MINUTES FROM GRAIN WORKING GROUP MEETING MAY 5th 2022

Talk from G. Laurenti about the current cryostat design:

Grain Cryo 1 ton LAr fiducial volume - tentative dimensions

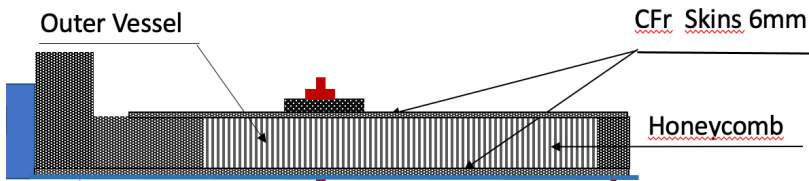
- which feedthroughs are we planning to use for the sensor readout? (G. Laurenti)
- which amount of heat loss can be tolerated? (G.Laurenti)
- which geometry for sensors can we use? (A.Montanari)

-the next goal is to design a cryostat with an effective volume of 0.7 m^3 , also considering the gas volume (15 cm from the top of the cryostat) and the lens dimensions (110 mm from SiPM surface)

- for the robustness of the design, an aspect ratio of the ellipse axis closer to 1 is favored
- if we want to decrease the thickness along the neutrino axis, the X dimension must be increased for keeping 1 ton LAr mass, but this will probably increase the vessel thickness dimensions. The current thickness of 12 mm was a first guess, the simu/physics group can check this number, together with the total cryostat thickness along the Z axis. How much do we gain for neutrino interaction reconstruction if the cryostat has thicker surfaces but smaller width along the Z dimension?

for lenses, you can consider the geometry shown in the meeting of 7th April, for mask we have to finalize that
